## REMARKS

In the September 27, 2004 Office Action, the Examiner noted that claims 17-31 were pending in the application; required information under 37 C.F.R § 1.105; objected to Figs. 1 and 2; rejected claims 17, 24, 28 and 31 under the second paragraph of 35 U.S.C. § 112; and rejected claims 17-31 under 35 U.S.C. § 102(a). In rejecting the claims, the Examiner cited "the admitted prior art (APA) of pages 1-3" (Office Action, paragraph 14, line 2). Claims 17 and 24 have been cancelled and claim 32 has been added. Thus, claims 18-23 and 25-32 remain in the case. The Examiner's rejections are traversed below.

FIG 1

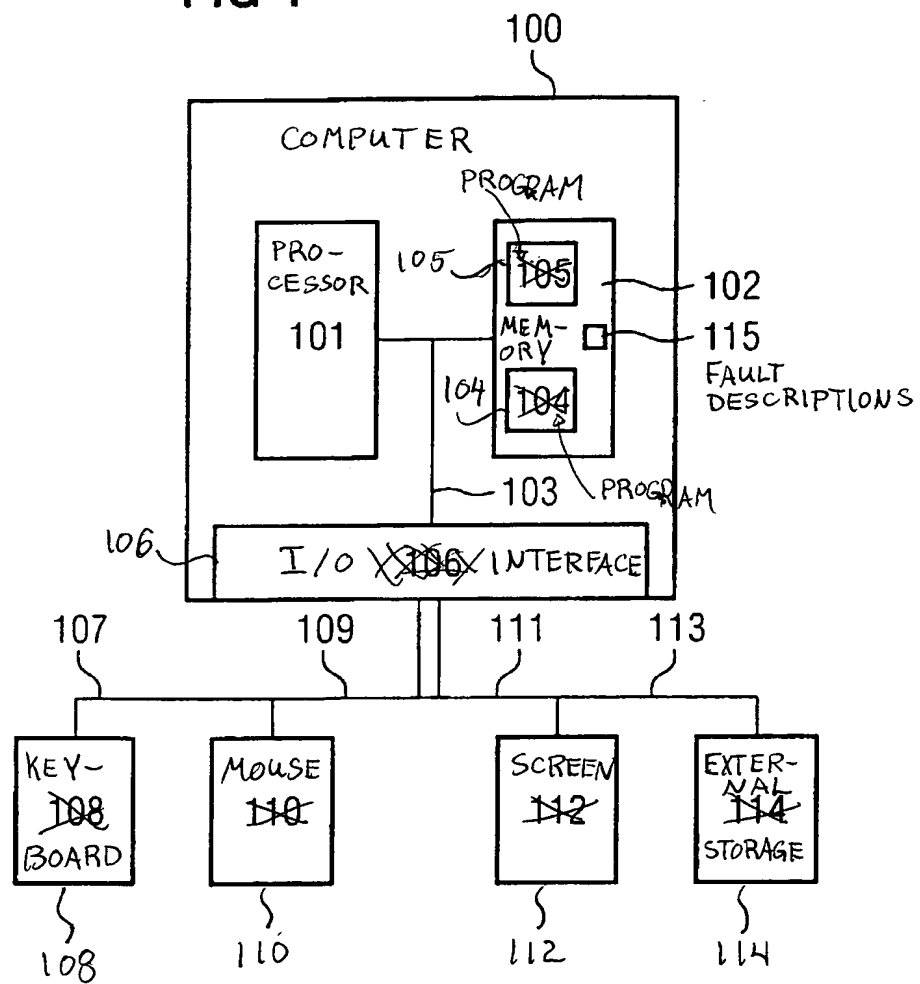
In item 10 on page 4 of the Office Action, the Examiner objected to Figs. 1 and 2 as containing "reference numerals without meaningful legends" (paragraph 10, line 2). No rule of the U.S. Patent and Trademark Office was cited in support. However, as noted above, the

In the Office Action at item 10, the Examiner objected to the drawings and required corrections. Replacement figures are submitted herewith adding as English legends the words in the Substitute Specification corresponding to the reference numerals in the drawings as filed. For the convenience of the Examiner, annotated sheets showing the changes made are attached. Approval of these changes to the Drawings is respectfully requested. Approval of these changes to the Drawings is respectfully requested.

words in the Substitute Specification corresponding to the reference numerals appearing in Figs. 1 and 2 have been added. Therefore, withdrawal of the objection is respectfully requested.
